Access Compliance Report

Public Rights-of-Way

(Curb Ramps)

Intersection ID: 17837	Main Street: CHARLESTOWNE_MANOR_DR	Cross Street: CHAUSLEY_CT	Location: E
ADA ID: EFE92A089D6A	Ramp Type: Directional	Initial Pass/Fail: Fail	Overall Compliance: No
Severity Score: 8.75			
Codes/Mitigation Info/Possible Solution		Field Measurements/Component Compliance

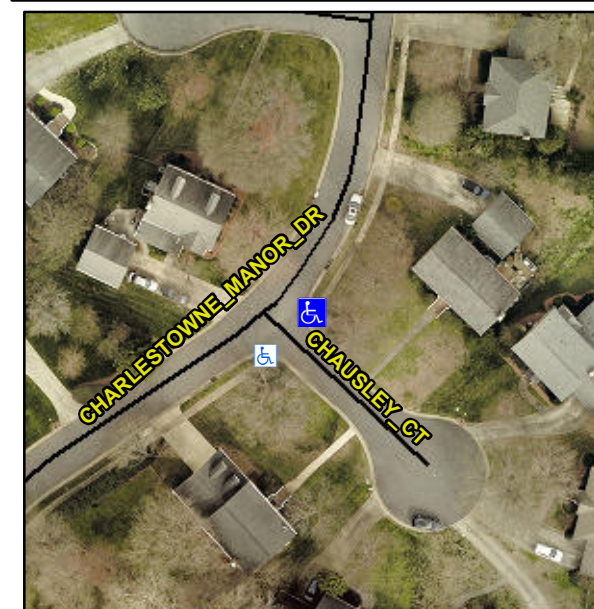
N/A

Remove & Replace Entire Ramp.

R304.5.1
